### Site Plan

The 10.23-acre site is proposed to have two points of access, both 24' in width, with one (1) curb cut off of Street "F" and the second off of Street "I", part of the Beulah Park public roadway network reviewed at the July 24, 2018 Planning Commission meeting. Drive aisles throughout the development are proposed to be 24-foot wide and provide access around the north, south and east sides of the structure. A temporary fire apparatus turnaround area constructed of gravel aggregate is provided in the northern portion of the site to allow trucks to properly maneuver around the site. Per Code Section 1137.11, this area must be constructed with concrete or asphalt instead. Curbing on site is proposed to be 18" straight curbing.

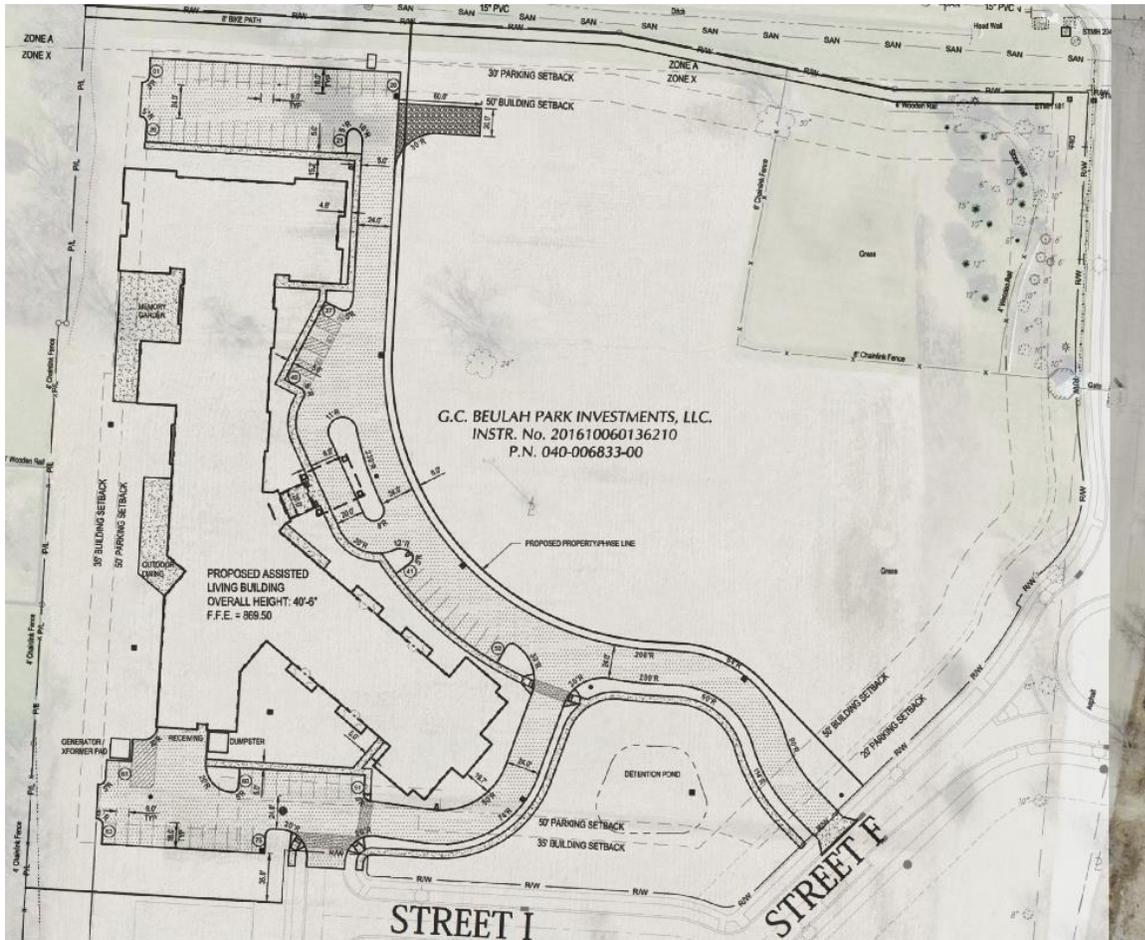
The proposed facility will have two (2) separate wings with a central community space. A memory garden and outdoor dining area are proposed along the rear/west portion of the building. The proposed building meets the setback requirements in the Beulah Park zoning text. This building, located in the western portion of the site, is the first phase of development for the subarea. A proposed second phase for a future expansion of the facility, on the subarea's eastern portion, will be reviewed as part of a separate development plan.

Sidewalks are proposed throughout the site and will be five (5) feet in width. The sidewalks will connect with the proposed sidewalks along Streets "F" and "I", along the eastern/front side of the building and will connect to each of the proposed parking areas. Three (3) stamped brick crosswalks are proposed on the site to connect the sidewalks over the access drives; however, a detail for the crosswalks will need to be added to the site details to show how they will be constructed. A bike path is shown along the northern edge of the property in accordance with the Beulah Park zoning text, which states that "pedestrian and bike connectivity shall be integrated throughout the site and along Southwest Boulevard."

An onsite stormwater detention pond is proposed in the southeast corner of the subarea. A more in-depth review of proposed stormwater detention and proposed drainage will occur during the Site Improvement Plan phase.

Plans show the location of a four (4) and six (6) foot chain-link fence. The applicant has indicated that the fencing is existing and will be removed during the demolition of the site with no new chain-link fencing proposed. Staff is not supportive of any chain-link fencing as it is not in character with the Beulah Park development.

1. The 20' fire-turn around area shall be constructed of asphalt or concrete as required in Section 1137.11.
2. No chain-link fencing shall be permitted and any existing chain-link fencing on the site shall be removed.
3. A note shall be added to the plans stating that all service structures shall be screened per Section 1136.08.
4. The height of proposed shrubs around the building shall be updated to be 24 inches minimum at installation.
5. The Tree Planting Typical shall be updated to state that 50% of the burlap and wire cage are to be removed from the rootball of the tree.
6. Sign details shall be submitted to the City for review to ensure they are in character with other entrance features and signage within the Beulah Park development.
